Access Compliance Report

Public Rights-of-Way

(Curb Ramps)

Intersection ID: 9399	Main Street: BATTLE_CT	Cross Street: LITTLE_HAMPTON_PL	Location: E
ADA ID: 04ECCFF879E0	Ramp Type: BlendTrans1	Initial Pass/Fail: Fail	Overall Compliance: No
			Severity Score: 33.75

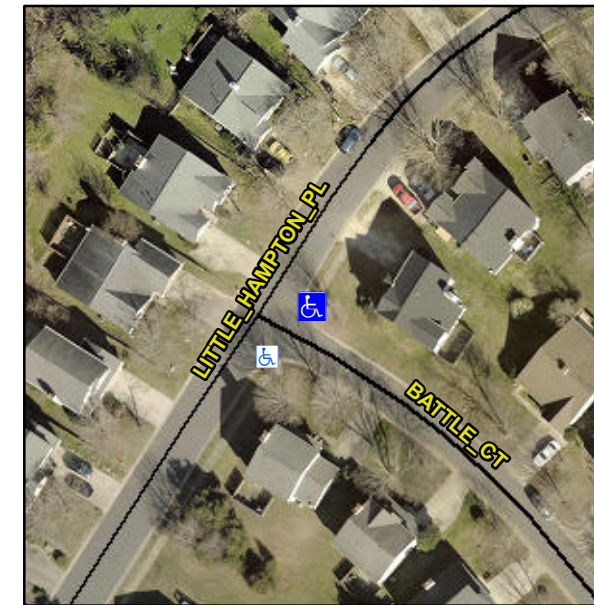
NO RT SW

Not Found, R304.5.1, R304.5.3

Remove & Replace Curb Ramp With Two New Directional Ramps or Equivalent.
